Subject: Second Letter Addendum to Workplan for Screening Level Soil and
Groundwater Sampling (Dated July 17, 2000)
Former Union Pacific Railroad Site
CDM Project No.: 8245-28614-WD21

Camp Dresser & McKee Inc. (CDM) is pleased to present this second letter addendum to address changes to the *Workplan for Screening Level Soil and Groundwater Sampling*, dated July 17, 2000. This letter updates and supercedes CDM's first letter addendum, dated August 9, 2000.

Sample Location Map
 Fruitvale Avenue to 35th Avenue
 BART Fruitvale Station
 Oakland, CA

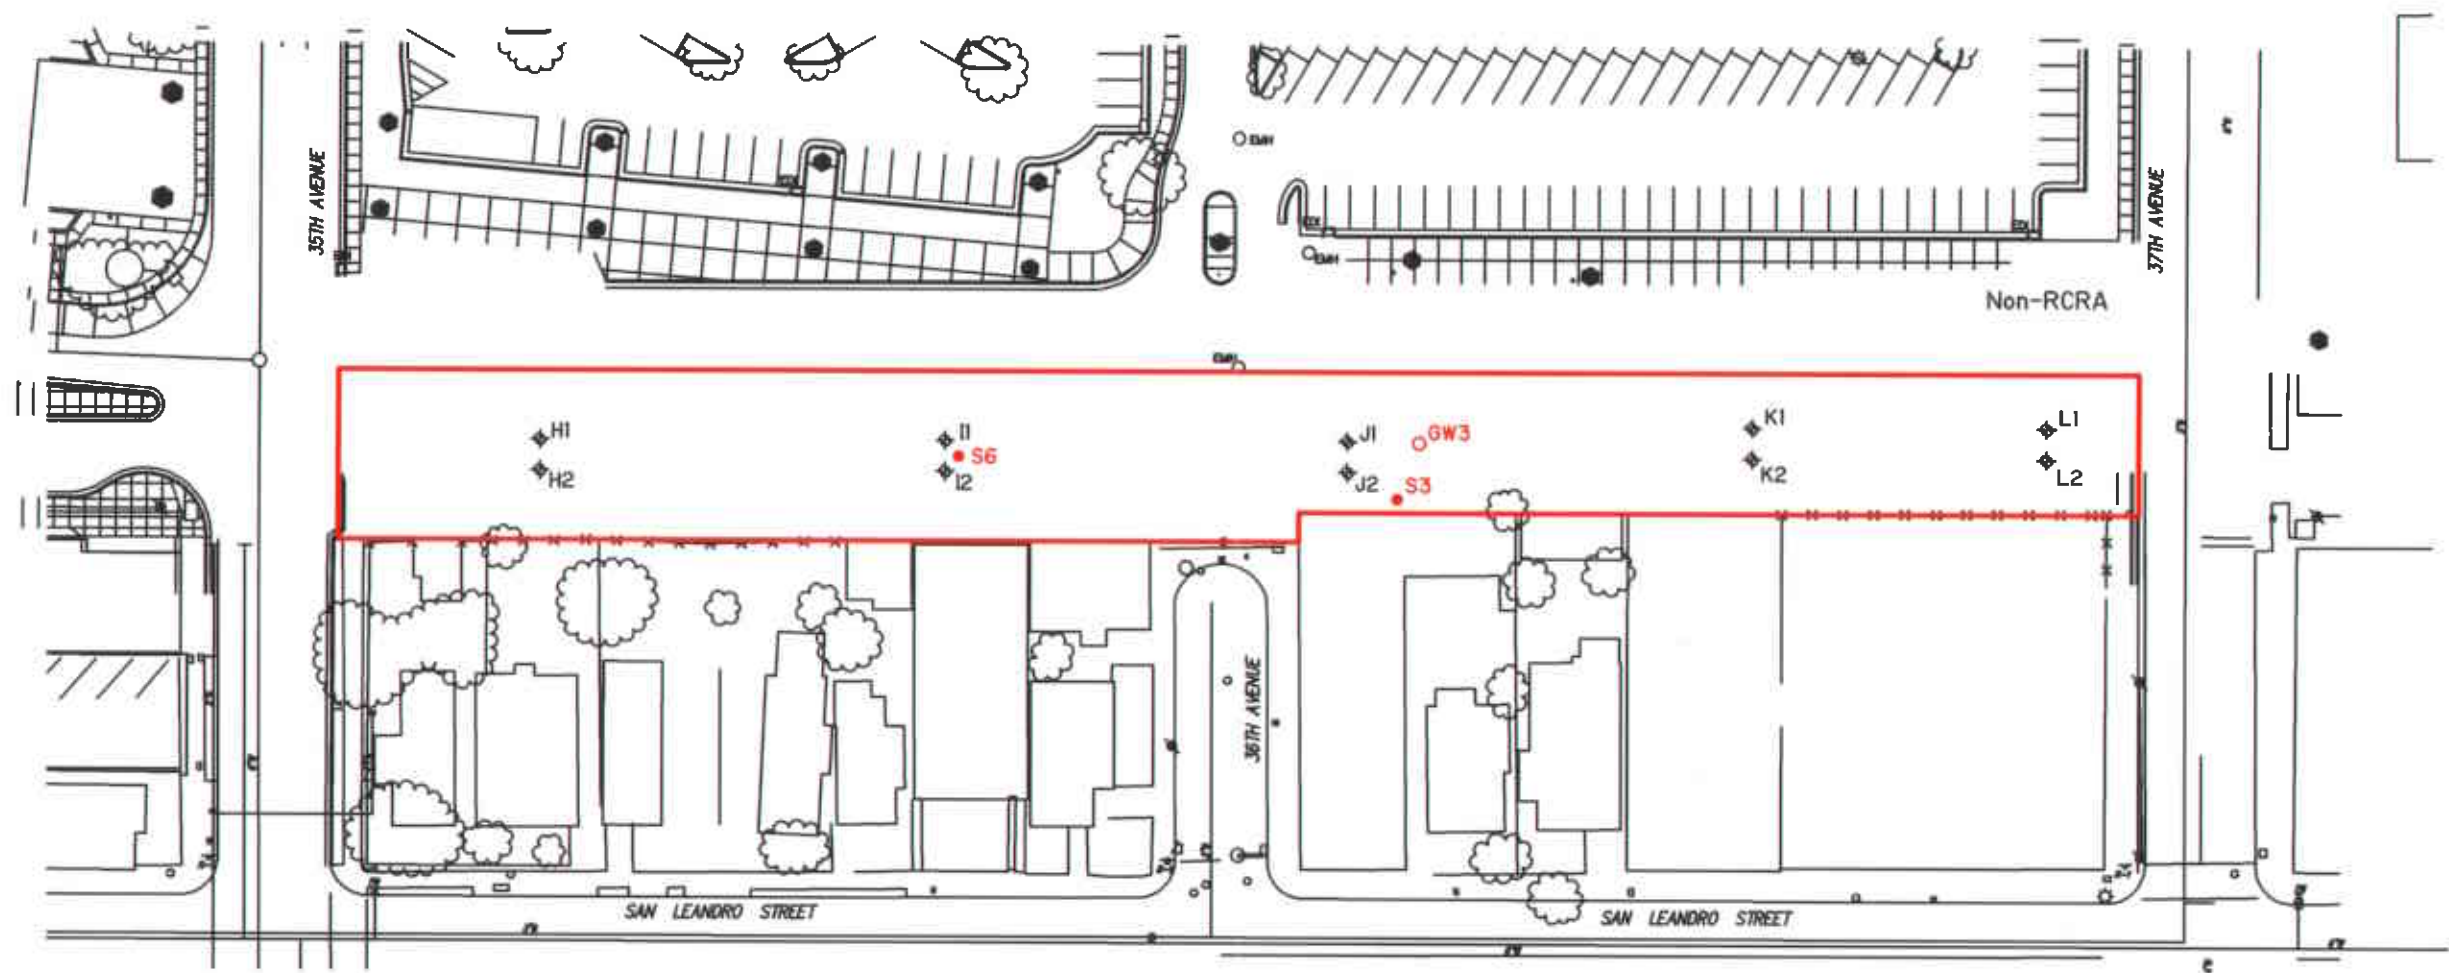
- Total of six soil sample locations will be located at former ARS locations. Specifically, sample locations S1, S2, and S3 will be located at adjacent to the former ARS Pit 7, 12, and 17/18 locations, respectively. The remaining three soil locations S4, S5, and S6 will be randomly distributed across the site (refer to Figures 3a and 3b, Sample Location Map). Soil samples will be collected at depths of 1 and 3 feet below ground surface (bgs).

- Total of four groundwater sample locations will be located at former ARS and CDM locations. Specifically, sample locations GW1, GW2, and GW3 will be located adjacent to former ARS Pit 7, 12, and 17/18 locations, respectively. In addition, sample location GW4 will be located adjacent to former CDM D1/D2 location. The drill rig will be advanced to a maximum depth of 30 feet bgs to collect to groundwater samples. If groundwater is not encountered with the 30 feet bgs, no groundwater samples will be collected.
- All soil and groundwater samples will be analyzed for the proposed analytes presented in Section 3 of the Workplan, as summarized in Table 1, Sample Collection Schedule and Laboratory Analyses.
